**Subject: Supplementary Information on Proposed Changes for the AP1000 Design Control Document Rev. 18**

This letter provides supplementary information on the design change (Change Number 05) which addresses a redesign of the Steel Containment Vessel Girder and Polar Crane Rail Clip Design. Information on CN05 was initially provided in References 1 & 3. The supplementary information, which consists of responses to comments provided by the NRC is provided in Enclosure 1. The resolution of these comments did not affect the DCD.

Supplementary Information for CN05  
Steel Containment Vessel Girder and Polar Crane Rail Clip Design  
(Non-Proprietary)

FIGURE 5

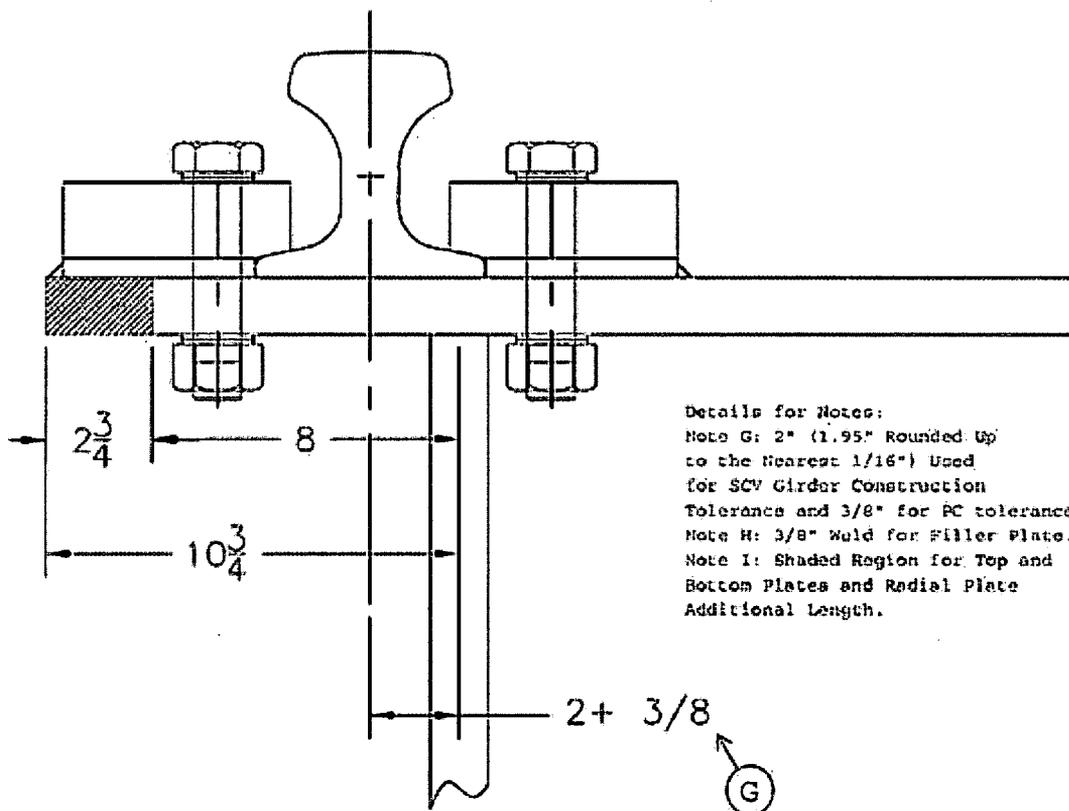
**Action Item #4:** NRC staff notes that the SCV girder is now extended inward by 2-3/4 inches. Based on the submittal, the reason for the change is that the tolerance requirement of the polar crane rail is much tighter than the SCV girder. Please provide the basis to justify that the increase of 2.75 inches inward of the SCV girder is quantitatively adequate to meet the tolerance requirement.

**Westinghouse Response:** In the design change proposal engineered inhouse, Westinghouse provided the basis for the inward extension of the CV girder top plate. An excerpt follows:

The PC is designed using, in part, ASME-NOG-1-1998 (NOG-1). NOG-1 requires the maximum and minimum span between the rails to be no greater or less than the nominal span of the rails  $\pm 3/8$ ". This tolerance is tighter than the construction of the SCV girder allows, based on input from industry experts. A tolerance of  $\pm 1.95$ " on the radius of the SCV girder is specified. Because of the difference in the tolerance requirements of the PC rail and constructability of the SCV, the girder (girder top plate, radial webs, and girder bottom plate) must be extended radially inward toward the center of the containment. Figure 5 shows the tolerance stack up and the required addition to the plates and radial plates of the SCV.

Therefore, the justification for the extension is the tolerance of the polar crane rail span and the tolerance of the CV itself. The stack-up tolerance required the extension of the top plate inwards.
